Product Change Notice (PCN)

Subject: Standardization of Lead Frame and Support Tape for Suzhou and Nishiki products in RH850 Series

Publication Date: 4/24/2025

Lead Frame: Before Change

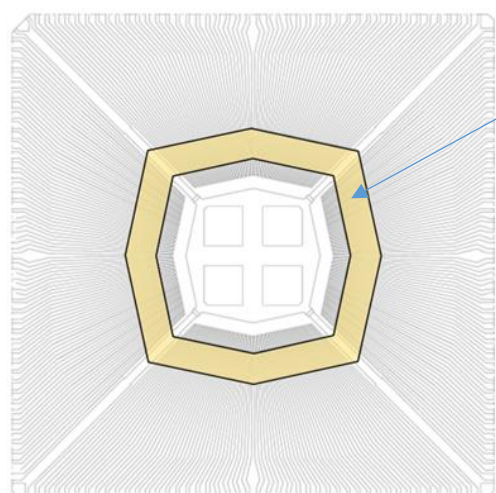
1. RH850/F1L, F1K and F1KM-S2 176pin products

Conventional Lead Frame and conventional Support Tape

Lead Frame: After Change

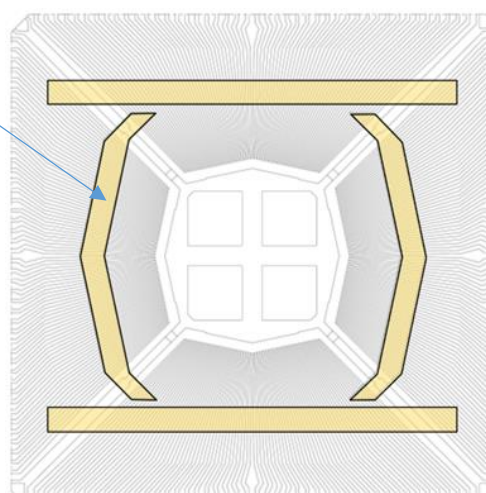
Standard Lead Frame and standard Support Tape

* Manufacturers of Lead Frame will attach Support Tape.

Lead Frame (e.g. 176pin): Before Change

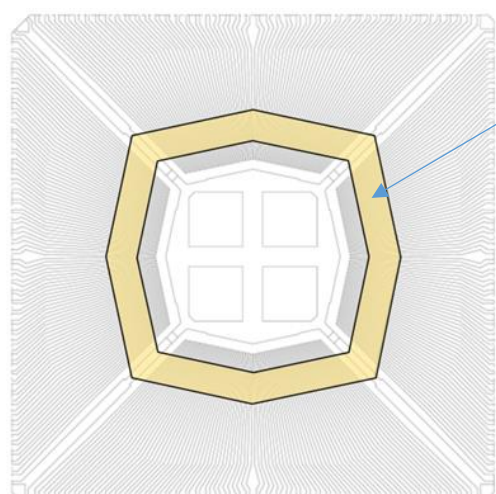
2. 176pin products other than RH850/F1L, F1K and F1KM-S2, and 144pin products.

Conventional Support Tape

Lead Frame (e.g.176pin): After Change

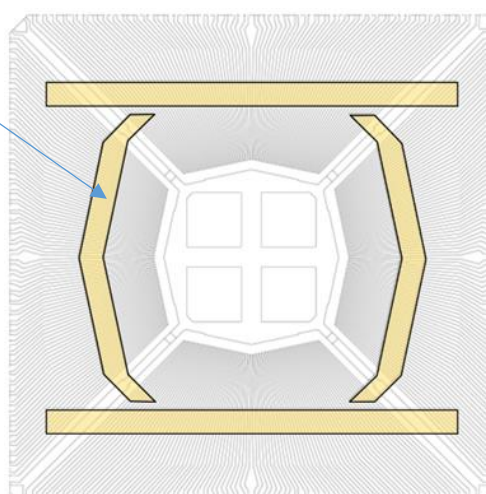
Standard Support Tape

* Manufacturers of Lead Frame will attach Support Tape.
